Proposed Amendments to the Eau Claire Area Redevelopment Plan

Oxford Lands
(Eau Claire Estates) and
Block Identification

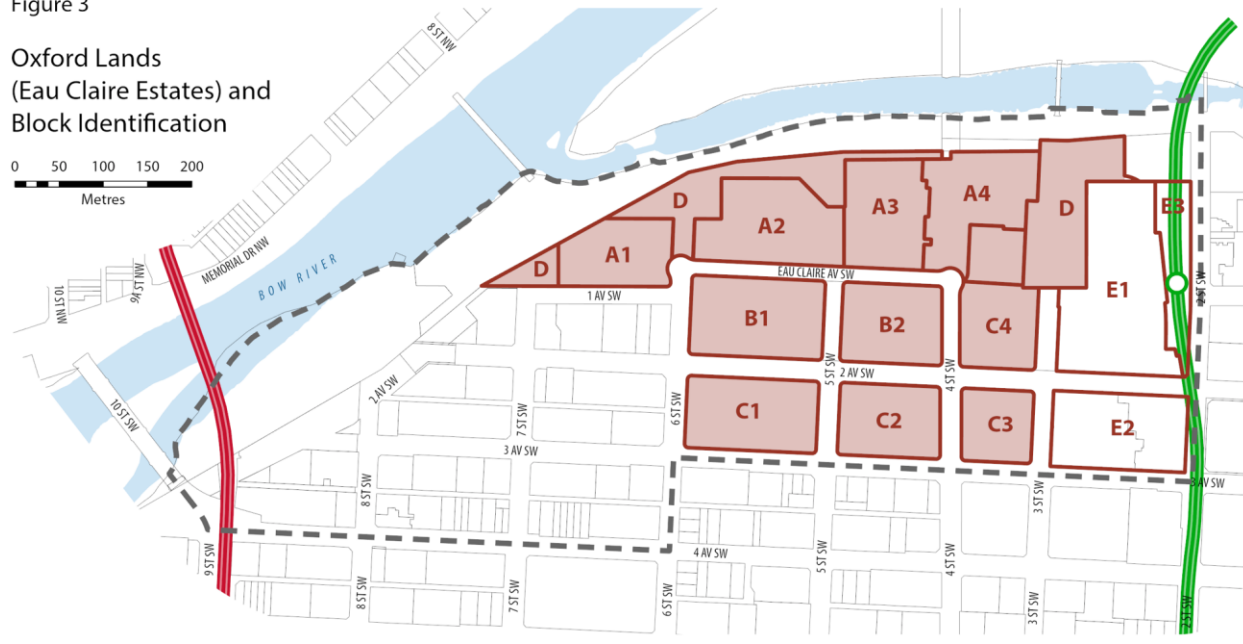
"In 2023, Block E3 was added to Figure 3 to recognize a revision in parcel boundaries on the existing Eau Claire Market site to allow for the development of the Light Rail Transit (LRT) Station along 2 Street SW. The E3 lands are directly adjacent to the E1 lands to the west and are bounded by 2 Street SW to the east, 2 Avenue SW to the south and another parcel of land to the north."
 - (e) Delete the existing Figure 4 entitled 'Major Building Locations' and replace with the revised Figure 4 entitled 'Major Building Locations' attached as Schedule D.
 - (f) In Section 2.0 Context, after subsection 2.9, add a new subsection 2.10, as follows:

Figure 5
Generalized Land Use

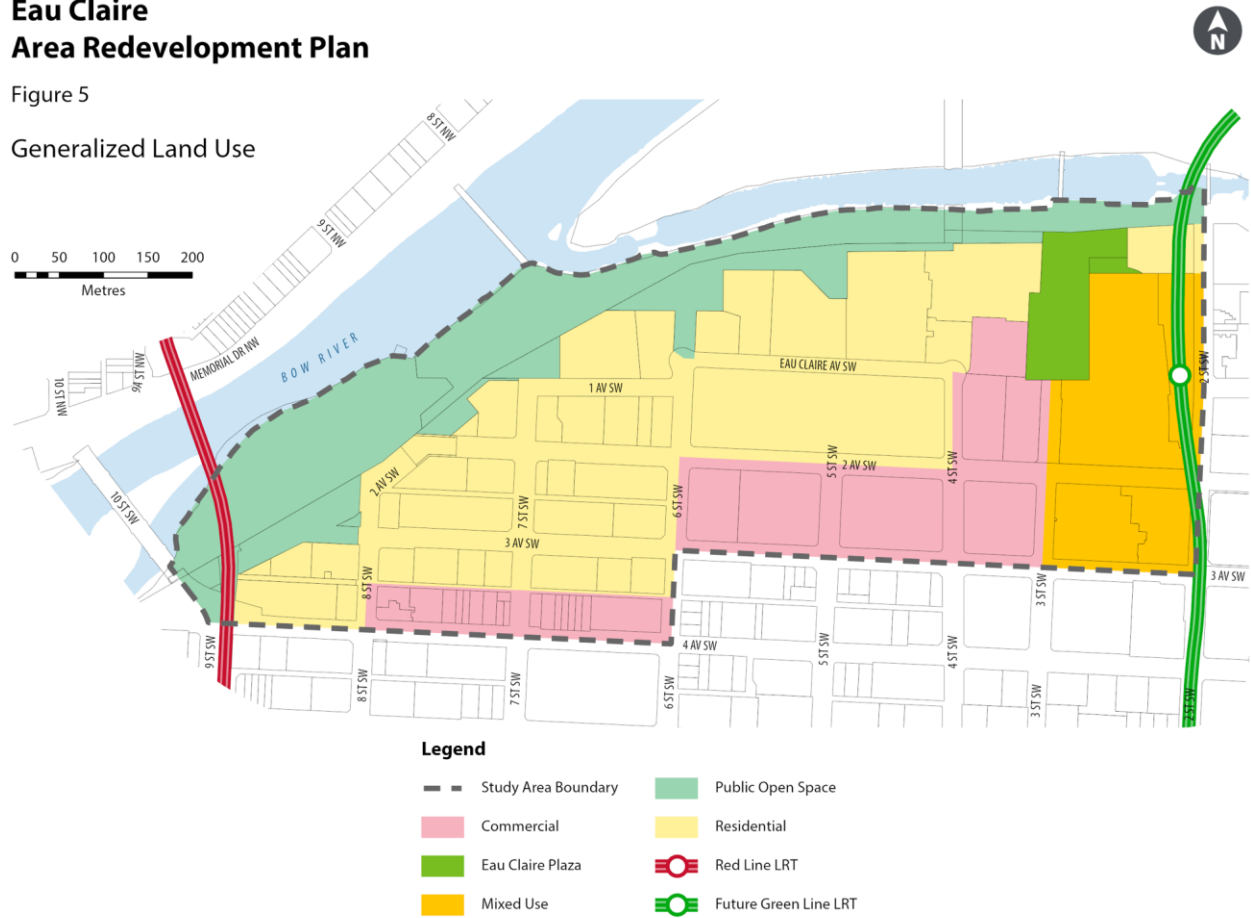
- (g) Delete the existing Figure 5 entitled 'Generalized Land Use' and replace with the revised Figure 5 entitled 'Generalized Land Use' attached as Schedule E.

Potential Major Land Uses,
Densities and
Building Heights

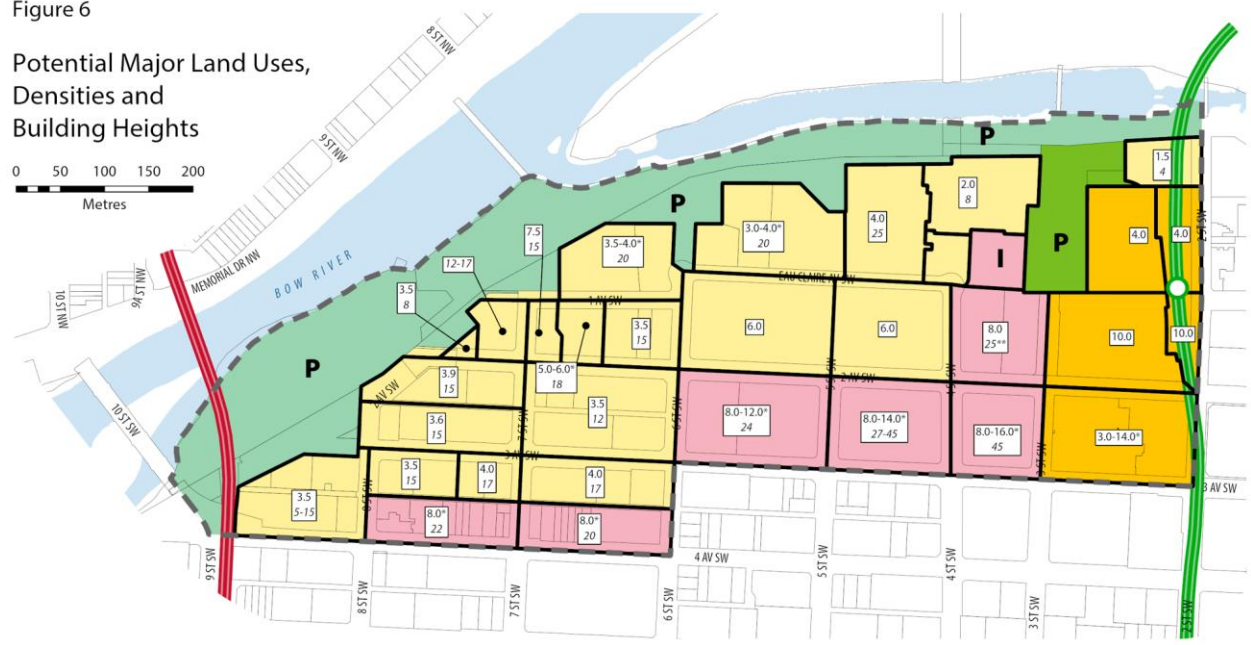
- (i) Delete the existing Figure 6 entitled ‘Potential Major Land Uses, Densities and Building Heights’ and replace with the revised Figure 6 entitled ‘Potential Major Land Uses, Densities and Building Heights’ attached as Schedule F.

Parks and Recreation Areas

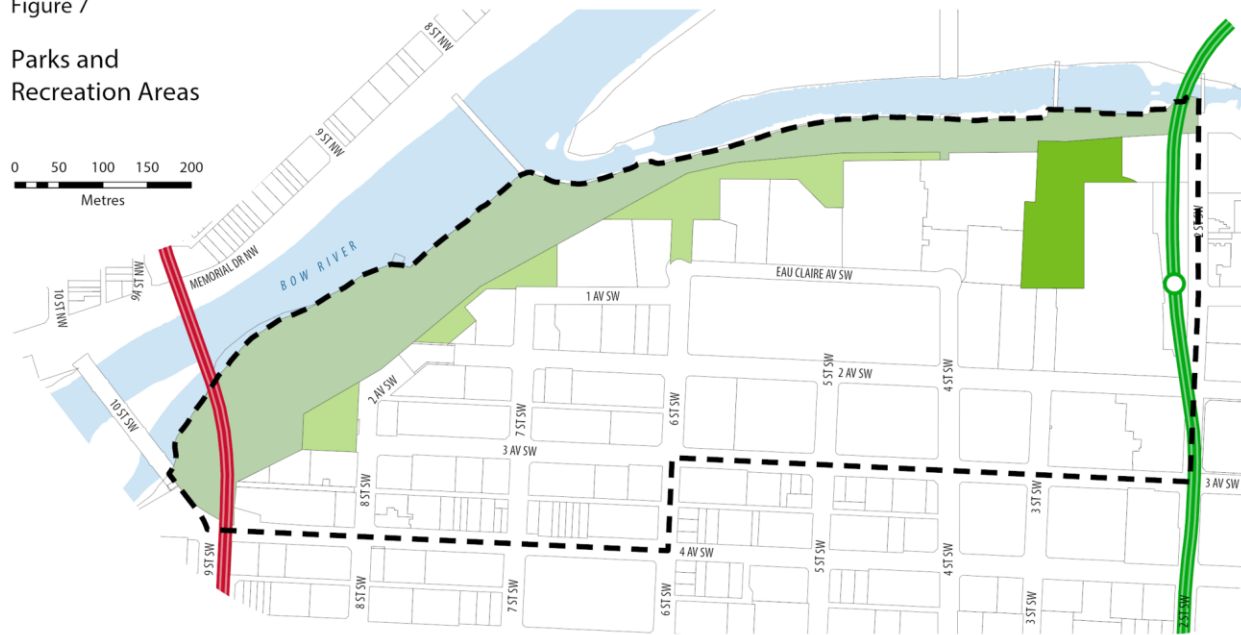
- (s) Delete the existing Figure 7 entitled ‘Parks and Recreation Areas’ and replace with the revised Figure 7 entitled ‘Parks and Recreation Areas’ attached as Schedule G.

Figure 8
Transportation System

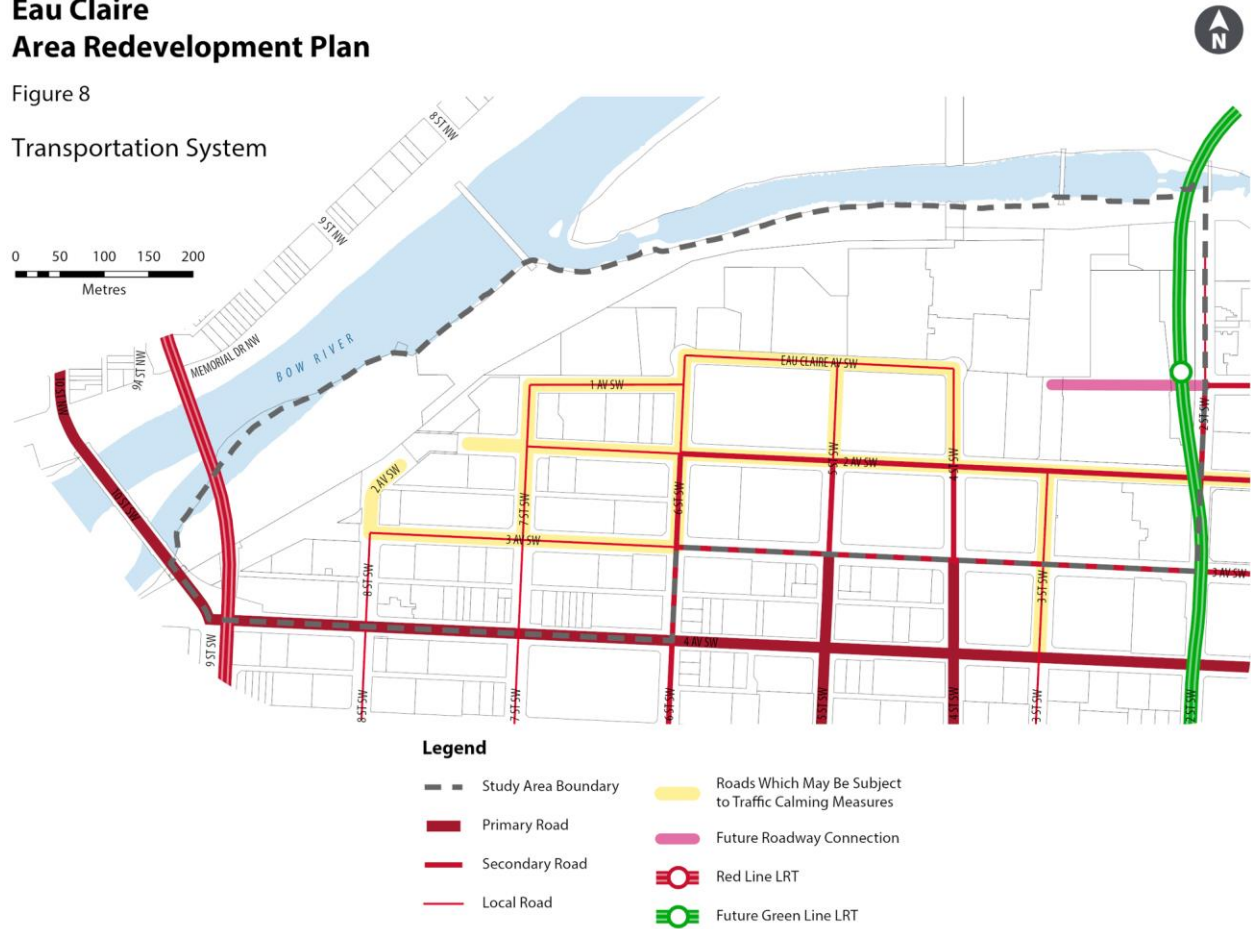
- (y) Delete the existing Figure 8 entitled ‘Transportation System’ and replace with the revised Figure 8 entitled ‘Transportation System’ attached as Schedule H.

Proposed Pedestrian Routes

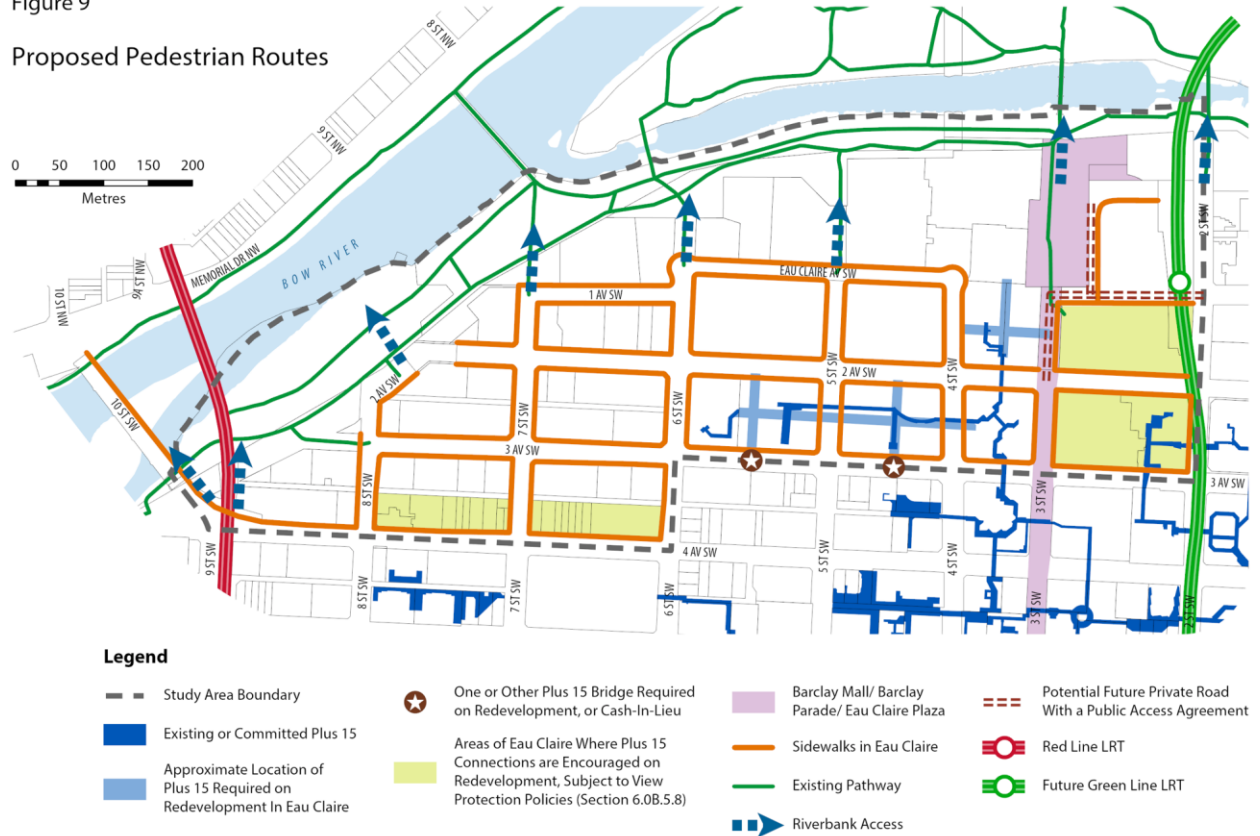
- (aa) Delete the existing Figure 9 entitled ‘Proposed Pedestrian Routes’ and replace with the revised Figure 9 entitled ‘Proposed Pedestrian Routes’ attached as Schedule I.
